**ATTACHMENT NO 1 - SCHEDULE OF SUBMISSIONS
CABLE BEACH PRECINCT STRCUTRE PLAN**

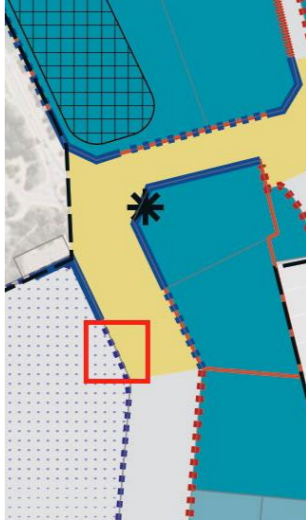
No.	Submitter Address	Summary of Submission	Local Government Response	Local Government Recommendation
		<p>- <i>It can be demonstrated that residential development will not have a negative impact on the primary tourism character or amenity of the CBP.</i></p> <p>The proposed percentage caps on permanent residential development are restrictive and does not provide flexibility for owners, both developers and owners of/in completed developments, to respond and adapt to changes in residential and tourism markets. The request to remove the above restrictions allowing developments to be 100% permanent residential, whilst maintaining Tourism as a permitted use is considered appropriate for the following reasons:</p> <ul style="list-style-type: none"> As mentioned above, tourism development in Cable Beach Precinct has stagnated over the last decade. Whilst we appreciate the Shire’s desire to maintain achieve tourism outcomes in the precinct, removing the percentage caps entirely increases opportunities for investment and enables owners to adapt more swiftly to changing market conditions, ensuring that the development aligns with current and future market needs. Given that tourism developments are not viable year-round, they often result in underutilised properties. Allowing for more flexibility in uses can fill this gap, ensuring that properties are utilised more effectively throughout the year and effectively responding to market demands. This will likely not only address housing supply issues, but also has the potential to contribute to greater affordability in the housing market, and further activate the Cable Beach Precinct. <p>c. Lifting of staging and development constraints</p> <p>The CBPSP further constrains owners adapting to changing market conditions and the seasonal nature of the Broome region, reducing flexible development outcomes by stipulating the following must be achieved for development to proceed:</p> <ul style="list-style-type: none"> <i>Prior to subdivision or development occurring, a development application which includes both the tourism and residential components, must be provided for the entire site.</i> <i>If the development is to be staged, the residential development is not to precede tourism development land uses.</i> <i>Where strata titling is proposed, a management statement is registered at the same time the strata or survey strata plan is registered that restricts the maximum length of stay to three months in any twelve-month period applied to the tourism accommodation.</i> <p>The above staging and development requirements further reduce the viability of development under the CBPSP and create additional hurdles for investment. It is requested that the above requirements are removed for the following reasons:</p> <ul style="list-style-type: none"> Predetermining the sequence of development phases can undermine the financial viability of an entire project. Furthermore, residential development can drive the provision of essential infrastructure and services, such as roads, utilities, and public amenities, ahead of the establishment of tourist development – and thereby increase the capacity for tourism outcomes to succeed. Forcing tourism development to precede residential development removes the flexibility to respond to market demand, leading to the potential for underutilised tourism facilities and delayed or stalled residential projects. Allowing development to proceed in any order can help establish a stable population base that supports local businesses and 	<p>c. Lifting of staging and development constraints</p> <p>It is also acknowledged that the requirement for the tourism development to proceed the residential component may restrict development, with the preference for delivery of residential first to stimulate development in Cable Beach.</p> <p>Recommend removing these requirements to allow for flexibility in the delivery of residential and tourism development in Cable Beach.</p>
